PLANNING CONSIDERATIONS

AUDP SUBMISSION
MIXED USE BUILDING - LOT E - SOUTH CAMPUS
June 4, 2015

LOCATION OF COMMERCIAL ENTRY

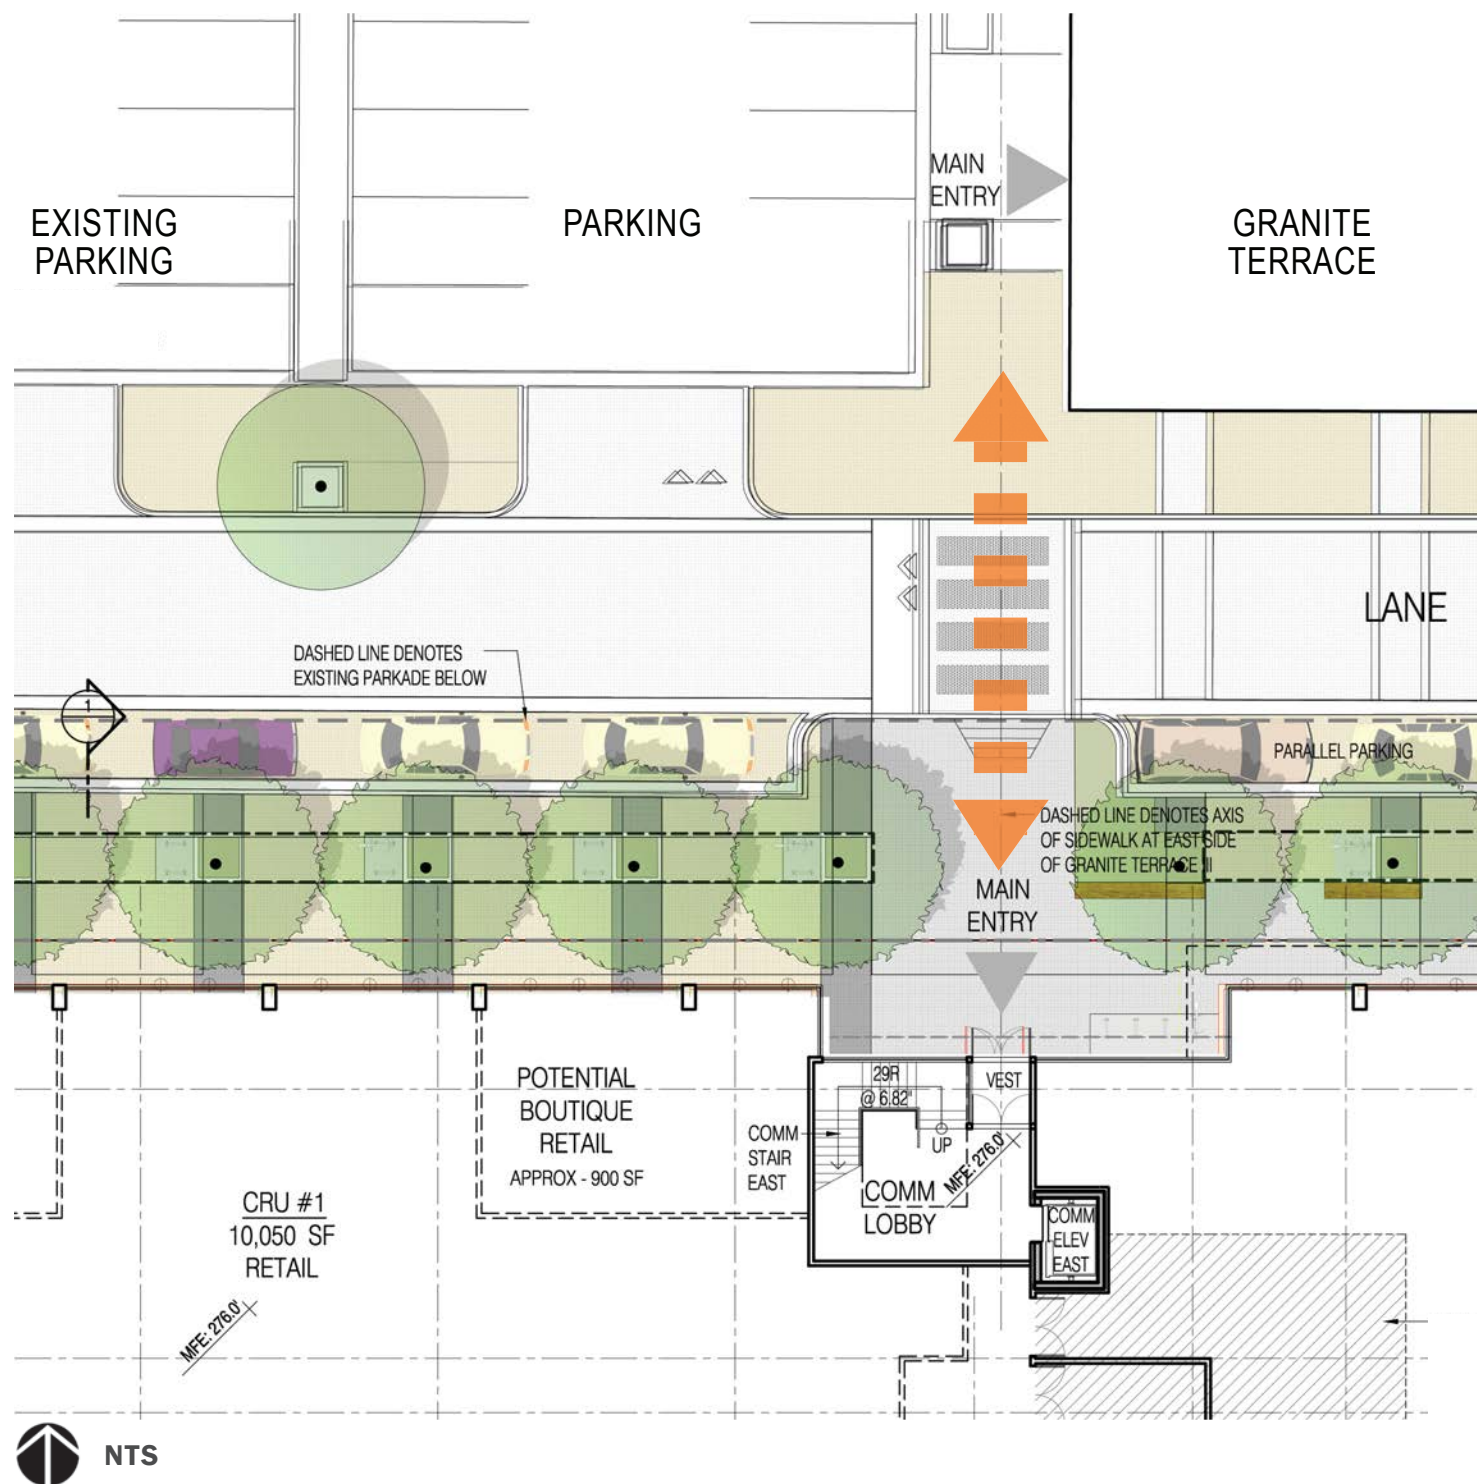
Commercial entrance has been shifted to the west to align with the axis of the sidewalk due west of the Granite Terrace III building to the immediate north of project site

PARTIAL PLAN L3-6 WEST ELEVATION

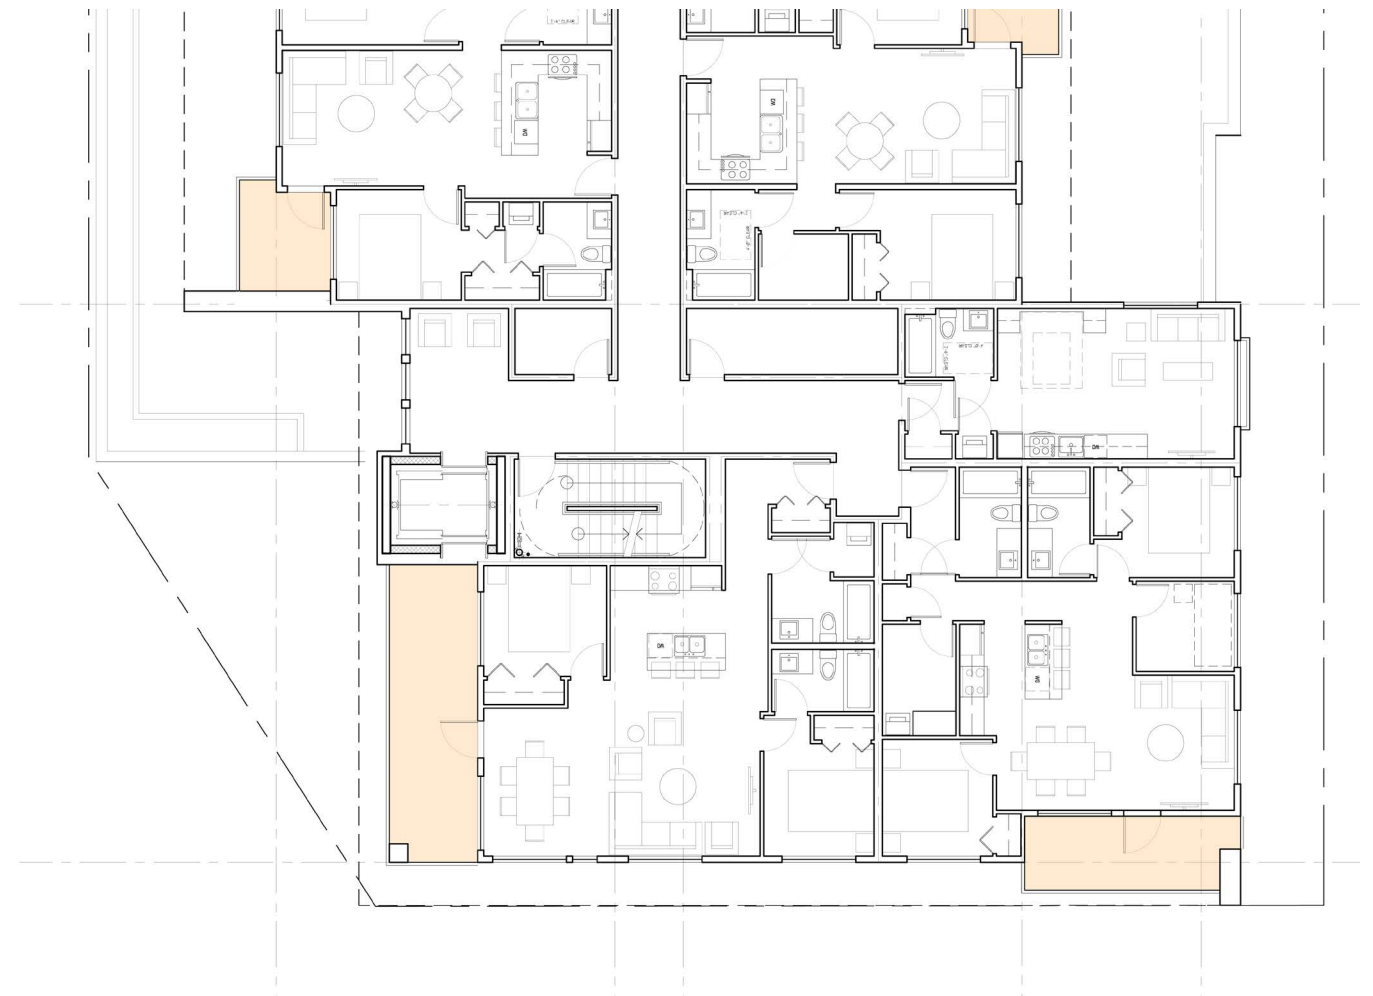
Unit plans have been revised to allow for more common areas & windows that face west to the park area.

Balconies at the west elevation have been revised to make the elevation more engaging as well as continue the rythm of the balconies from the north to the south elevation

LANDSCAPE EXISTING TREES

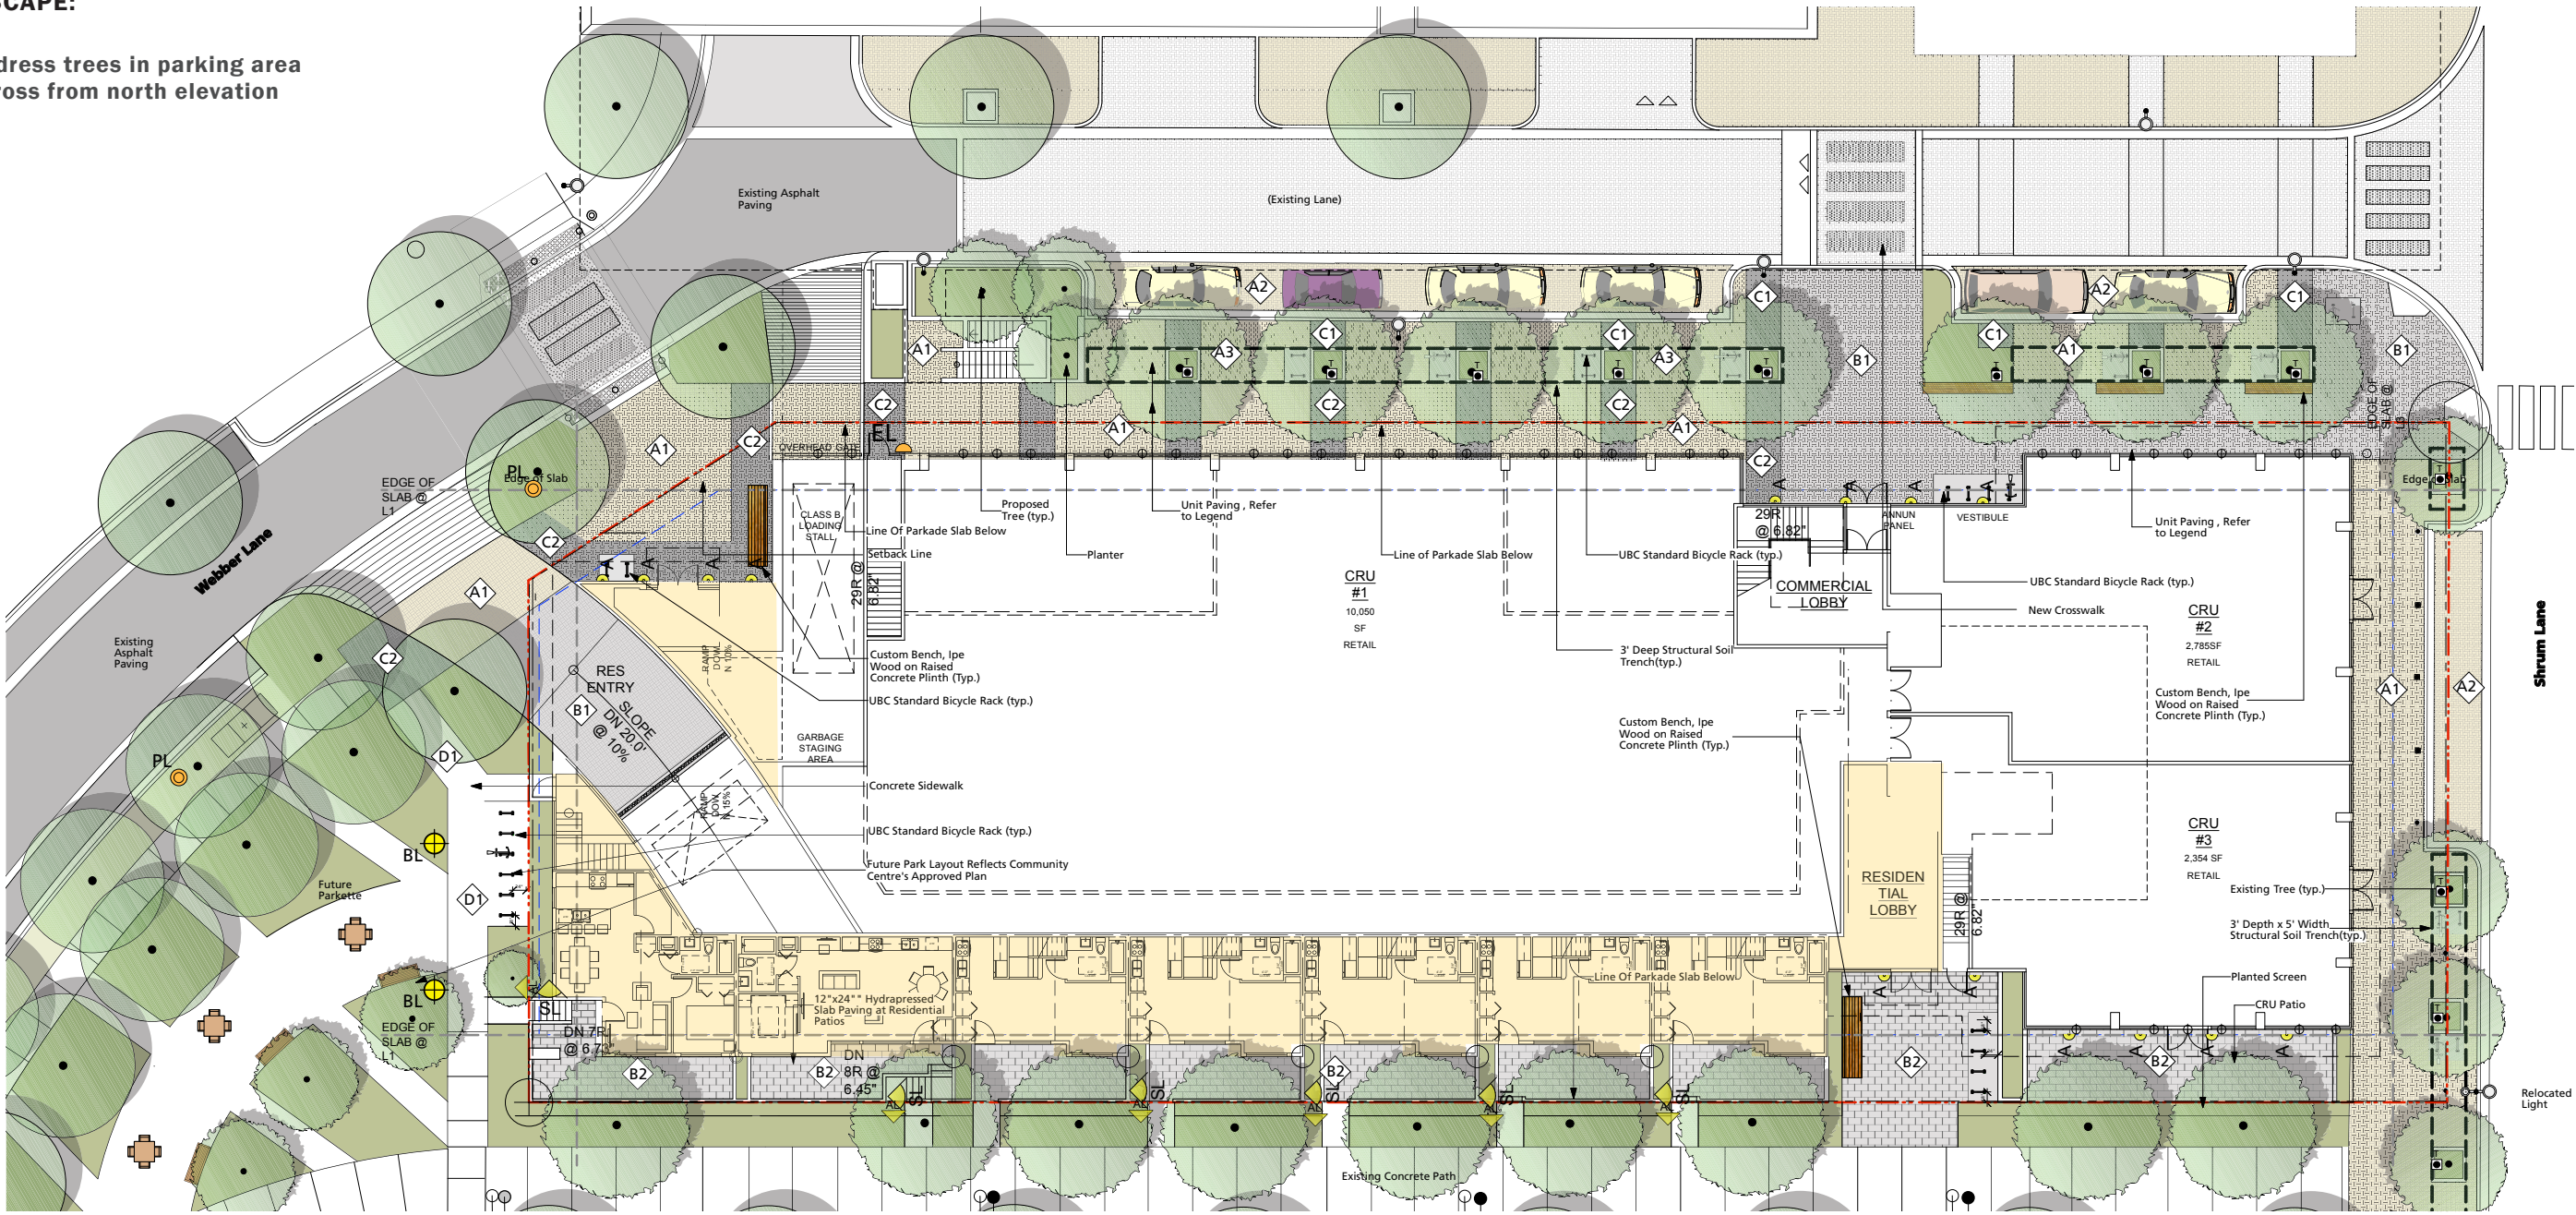
- Address trees in parking area across from north elevation
